30 Apr 2003

From: Customer Liaison Officer  
To: Quality Assurance Officer

Subj: FA-18 HYDRAULIC SYSTEM SERVICING

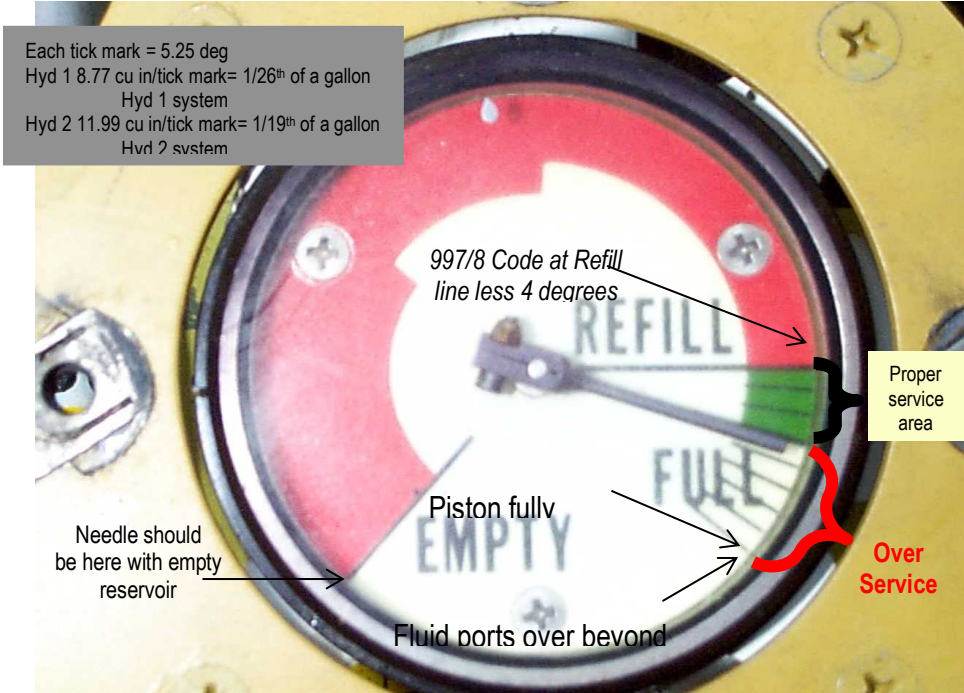
**Direct Cause:** 997 (Hyd 1 low) and 998 (Hyd 2 low) are the result of a mechanical interface that pops the code whenever the needle on the gauge dips below the Refill line less 4 degrees (slightly less than 1 tick mark which is 5.25 degrees).

**Contributing Cause:** Equipment/Tool Deficiency- Calibration expired/inaccurate. A walk through building 94 will show many of the hydraulic gages on empty aircraft hydraulic systems showing many different positions other than an angle coincident with "Empty" on the gage. This is verified by test line personnel adjusting the needles themselves on systems they have to drain for any unscheduled maintenance. If the system gets "over serviced" as a result of an inaccurate needle but the needle shows it "in the green", then the excess fluid will get vented overboard thus dropping the needle in the red and a vicious cycle of chasing the needle follows.

**Root Cause:** Management Supervisory Deficiency- Work organization/planning deficiency. Building 94 artisans must be responsible for adjusting the gauges when the system is bled.
